E/ECE/324
E/ECE/TRANS/505 } Rev.1/Add.43/Amend.5
17 April 1991

Addendum 43: Regulation No. 44

Amendment 5

UNIFORM PROVISIONS CONCERNING THE APPROVAL OF RESTRAINING DEVICES FOR CHILD OCCUPANTS OF POWER-DRIVEN VEHICLES ("CHILD RESTRAINT SYSTEM")

ARRANGEMENTS OF THE APPROVAL MARK

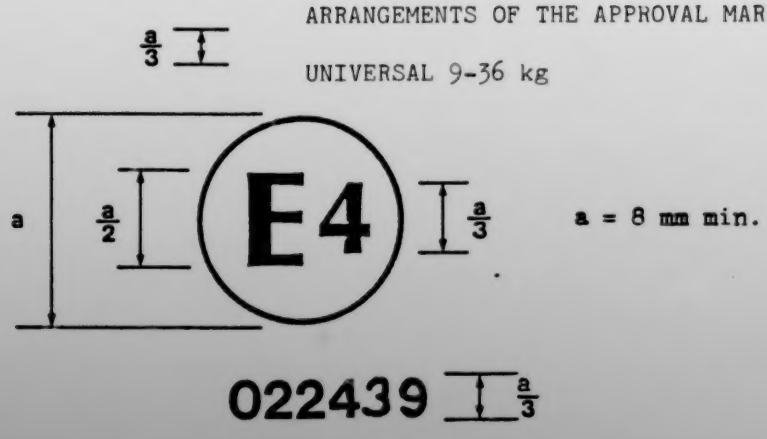
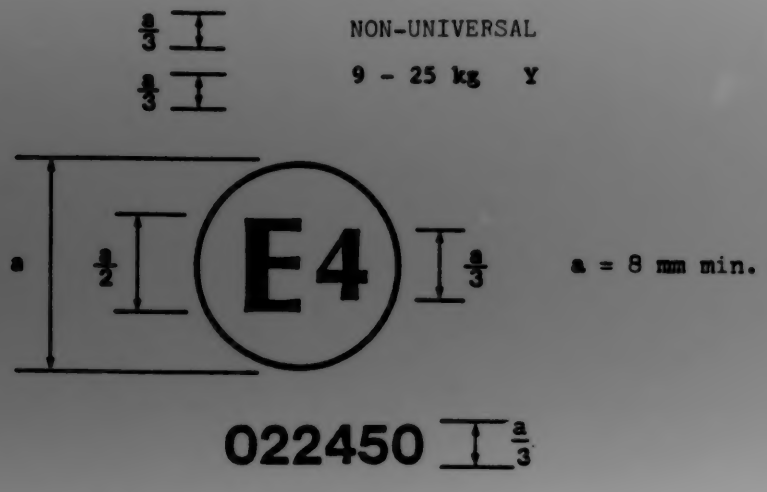
Annex 2: Amend to read:

NON-UNIVERSAL

9 - 25 kg Y

The child restraint system bearing the above approval mark is a device not capable of being fitted in every vehicle and of being used for the 9 kg-25 kg mass range (Groups 1 and 2); it is approved in the Netherlands (E4) under the number 022450. The approval number indicates that the approval was granted in accordance with the requirements of the Regulation concerning the approval of restraining devices for child occupants of power-driven vehicles ('child restraint system') as amended by the 02 series of amendments. The symbol 'Y' indicates that the system contains a crotch strap.
